ILLINOIS POWER COMPANY

Subject: 10CFR Part 21 Defect in  
Rosemount Transmitter Amplifier Board  
Functional Problem (21-84-10)

Subject: Notification Under 10 CFR Part 21 Regulations

# OPERATIONAL AMPLIFIER LOCATIONS

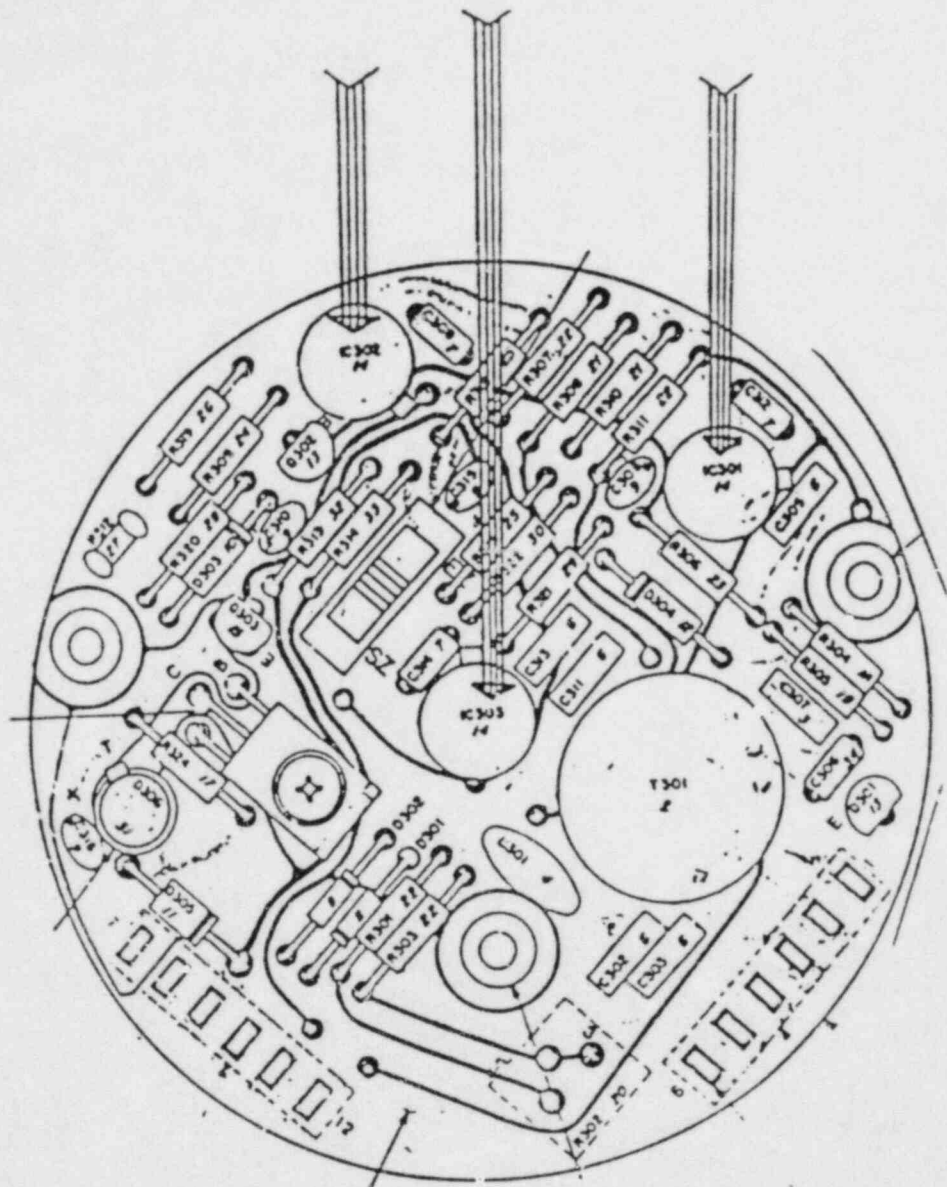
This suspected board can be identified visually by inspecting the circuit side of the board, and specifically the three operational amplifiers shown in the enclosed board layout print. The suspect board has Op Amps marked with the letters "PM", in addition to the date code on the top of the can. If your inspection finds this board, we are requesting you replace it with the one we have enclosed and then call Mr. R. Volsted at A/C 612-828-3473 for disposition of the replaced board.

## SUSPECT MARKINGS

"N" or "N20"

"PM"

## ACCEPTABLE MARKINGS

"N" or "N20"  
(No other markings)
